*Kane County Division of Transportation
Longmeadow Parkway Section C1 – Contract 63955*

Addendum #2 – September 27, 2018

Addendum #1, as issued by the Kane County Division of Transportation on September 25, 2018, includes the following revisions and clarifications:

RAILING DETAILS			
STRUCTURE NO. 045-3024			
SCALE:	SHEET 22	OF 90 SHEETS	STA. TO STA.

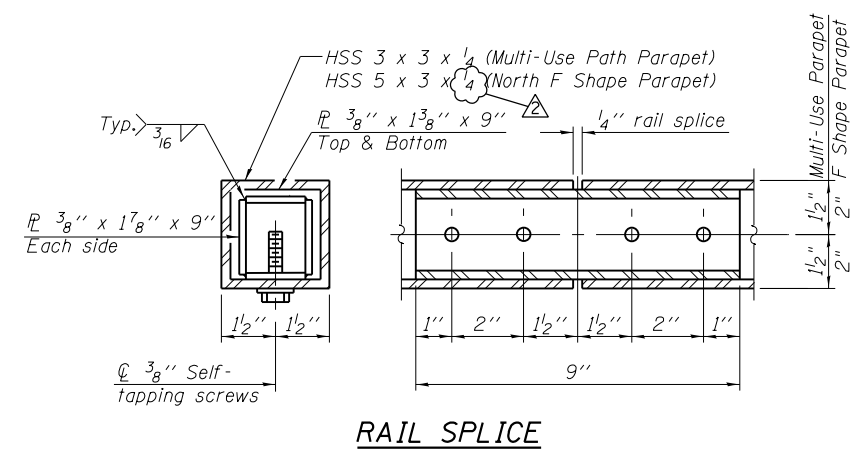
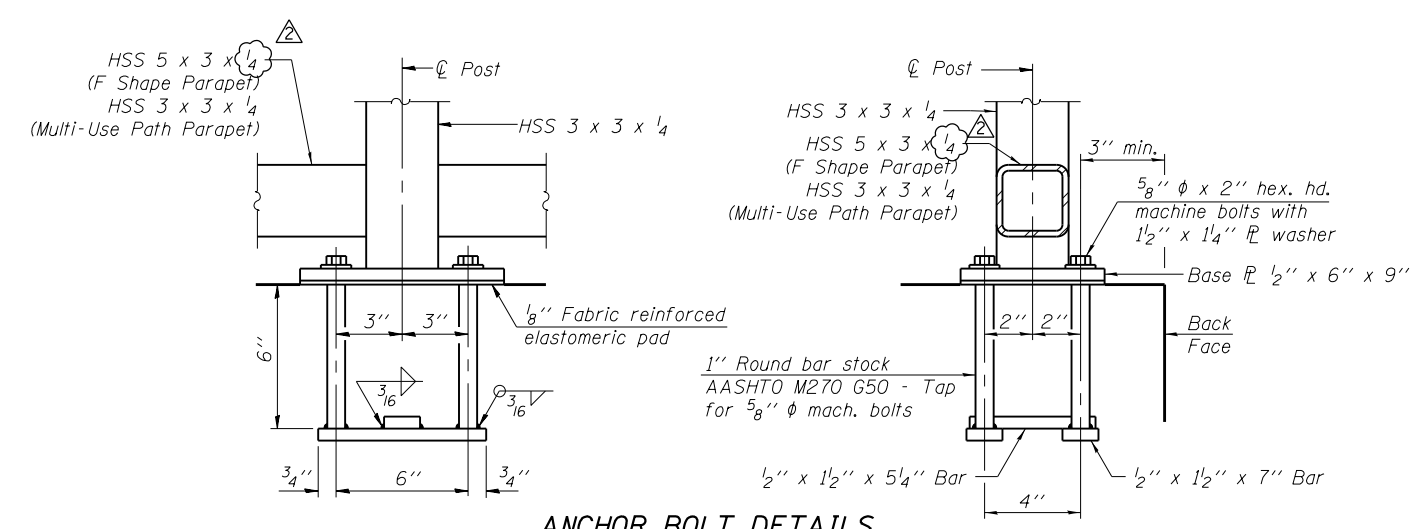
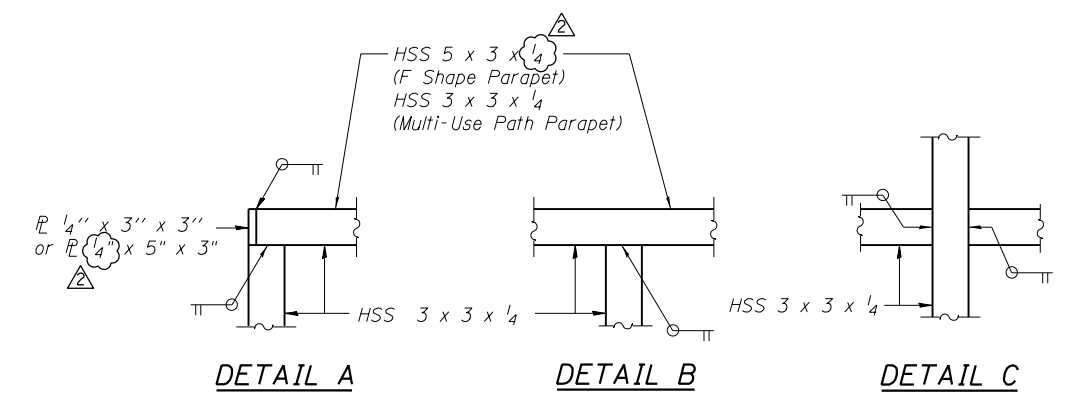
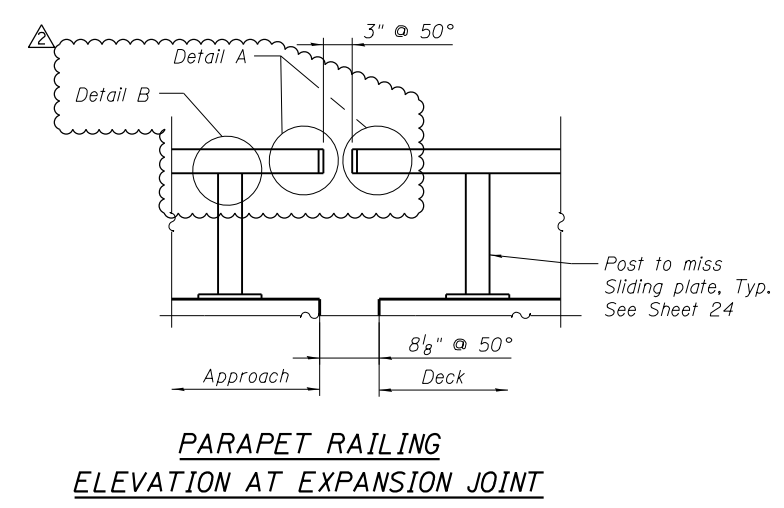
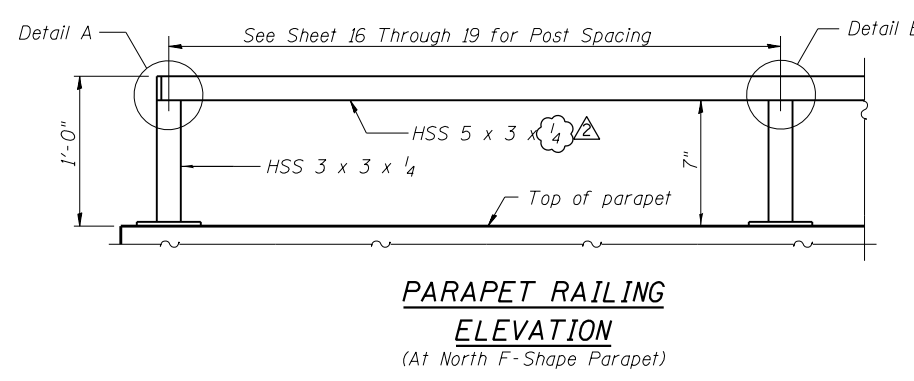
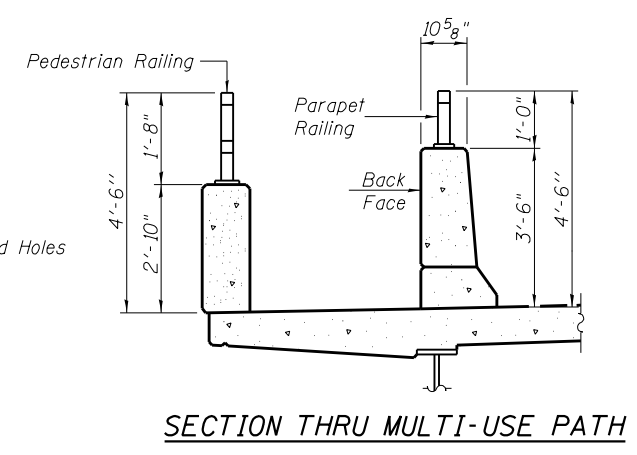
- Sheets 116, 154, & 171 - Revised the parapet railing on the F Shape Parapet from HSS 5 x 3 x ½ to HSS 5 x 3 x ¼. Also, revised the Parapet Railing Elevation at Expansion Joint Detail to indicate the appropriate detail that is to be referenced at various locations along the railing.
